**Honor Our Pueblo Existence (H.O.P.E),
Concerned Citizens for Nuclear Safety (CCNS), and
Robert H. Gilkeson, Independent Registered Geologist**

August 20, 2013

Re: *Comments for the August 20, 2013 Meeting with the Defense Nuclear Facilities Safety Board in Santa Fe, New Mexico*

Seismic Hazard Curves For Peak Horizontal Ground Motions From Simultaneous Ruptures From A Single Earthquake At the location of LANL PF-4, the RLUOB and the proposed CMRR-NF. Source: Figure 7 in the LANL 2009 PSHA Report.

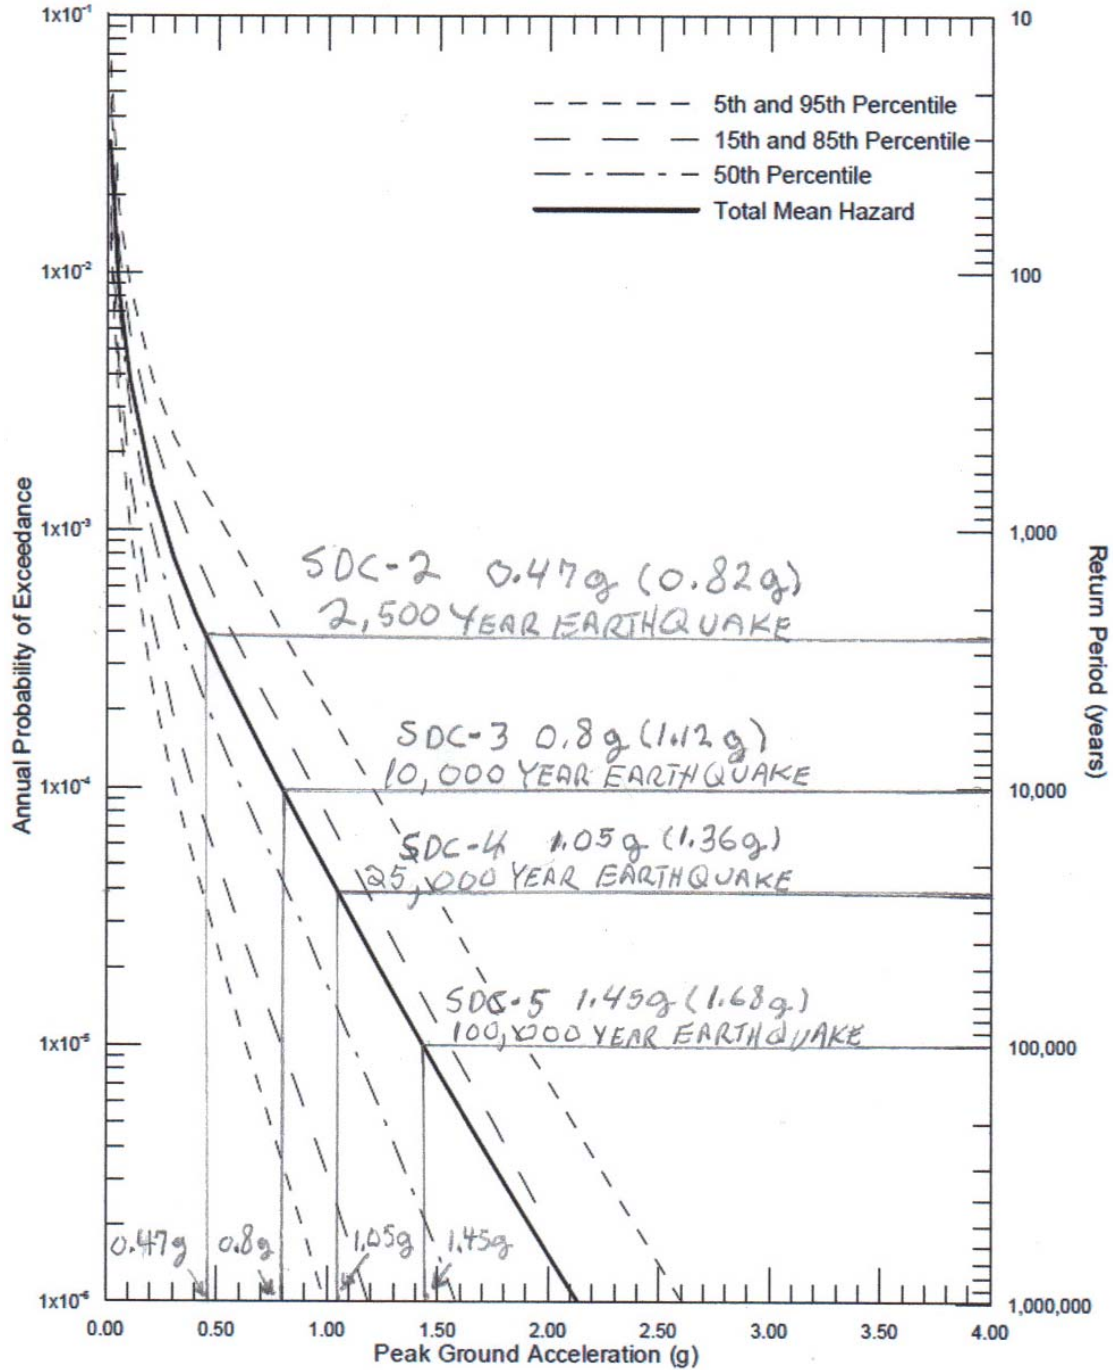
A graph of the large earthquake ground motions calculated in the LANL 2007 and 2009 Probabilistic Seismic Hazard Analysis (PSHA) Reports is attached to this report.

- The LANL reports state that the alternate analysis is for ground motions of ~0.5 g. However, DOE Standard 1020-2012 requires the PF-4 to provide confinement of the large inventory of plutonium for ground motions from a SDC-5 earthquake that are more than three times greater at 1.68 g.
- Will the DNFSB require DOE, NNSA and LANL to perform the “alternate” analysis for ground motions of 1.68 g?

Note: The larger ground motions for synchronous earthquakes for each earthquake return period are in parentheses on the figure. The synchronous ground motions were calculated from Figure 8.
